Proposal for SAS 2.x Specification to Enable Support for Active Cables

Gourgen Oganessyan

QUELLAN

August 12, 2008

Figure 98 — Mini SAS 4x cable plug connector that attaches to an enclosure universal port

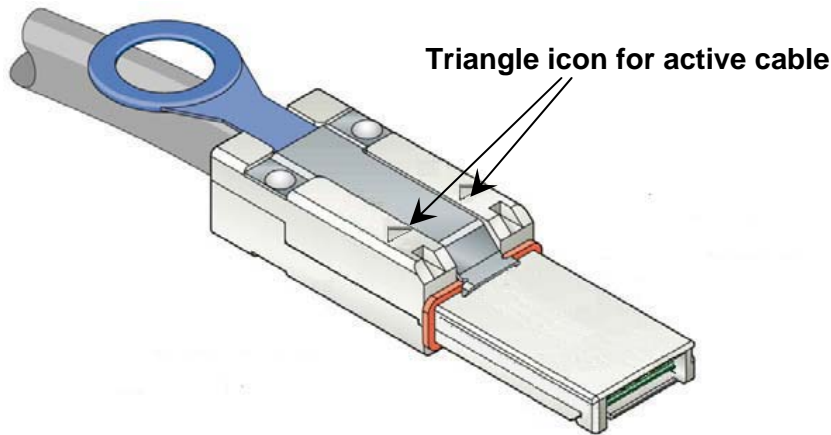
In order to ensure that active cables are not intermateable with passive receptacles, differentiating keying shall be provided by removing all the key slots from the plug connector and all the keys on the receptacle connector. In addition, two triangle icons on each side on

the plug connector shall be added to the plug connector to identify an active cable assembly. These key positions and icons are summarized in Table 58.

Figure 98 shows an active mini SAS 4x cable plug connector that attaches to an enclosure universal port:

Figure M.1 — Dual comparator design for active cable detection

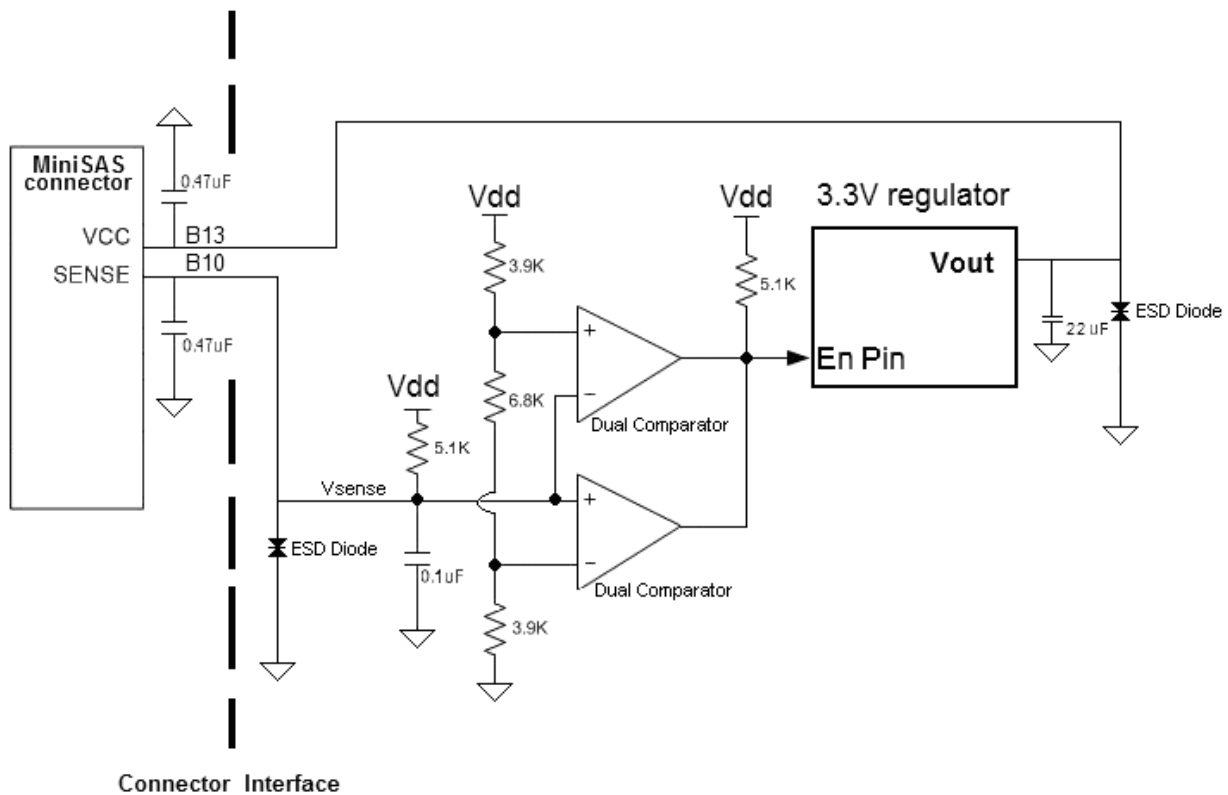
- *Edited most of the wording throughout the document to conform to the T10 style guide and to incorporate comments received from the group*
- *Deleted the minimum value for Supply Current in Table 61 and changed the maximum value from 600 mA to 319.4 mA.*
- *Edited the Informative Annex M to conform to the T10 style guide, dropped Table M.1 (parts List) and edited Figure M.1 to identify the function of the components.*

Fig M1 is an example design utilizing a dual comparator to determine from the sense pin on the active cable plug if an active cable is in operation. The circuit then supplies power based upon whether there is an active cable connected to the receptacle.
